Access Compliance Report

Public Rights-of-Way

Intersection ID: 25678	Main Street: CARMEL_EXECUTIVE_PARK	Cross Street: CARMEL_RD	Location: W
ADA ID: BFC0B44262E2	Ramp Type: IslandPerp	Initial Pass/Fail: Fail	Overall Compliance: No
Severity Score: 12.5			
Codes/Mitigation Info/Possible Solution		Field Measurements/Component Compliance

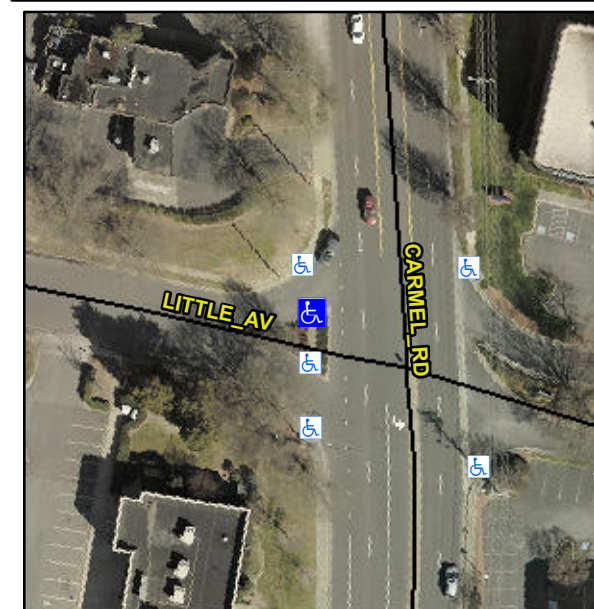
Not Found, R304.2.2

Compliance	Description	Data	Compliance	Description	Data
N/A	Ramp Length (in)	70.0	No	Ramp Slope (%)	8.6
Yes	Ramp Width (in)	54.0	Yes	Ramp XSlope (%)	2.0
N/A	Flare Type LT	N/A	N/A	Flare Type RT	N/A
N/A	Flare Slope LT (%)	N/A	N/A	Flare Slope RT (%)	N/A
N/A	Flare Traversable LT?	N/A	N/A	Flare Traversable RT?	N/A
N/A	Landing Length (in)	N/A	N/A	DWS Provided?	N/A
N/A	Landing Width (in)	N/A	N/A	DWS Contrast?	N/A
N/A	Landing Slope (%)	N/A	N/A	DWS Length (in)	N/A
N/A	Landing X Slope (%)	N/A	N/A	DWS Full Width?	N/A
N/A	Landing Curb? (Y/N)	N/A	N/A	DWS Offset (in)	N/A
N/A	Shared Landing?	N/A			
N/A	Gutter Ponding?	N/A	N/A	Gutter Slope (%)	N/A
N/A	Gutter Lip Ht (in)	N/A	N/A	Gutter X Slope (%)	N/A
N/A	Painted X Walk1?	No	N/A	Painted X Walk2?	N/A
	X Walk 1 Direction	To N		X Walk 2 Direction	N/A
N/A	X Walk 1 Width (in)	N/A	N/A	X Walk 2 Width (in)	N/A
	X Walk 1 Slope (%)	1.0		X Walk 2 Slope (%)	N/A
	X Walk 1 X Slope (%)	0.1		X Walk 2 X Slope (%)	N/A

Remove & Replace Entire Ramp.
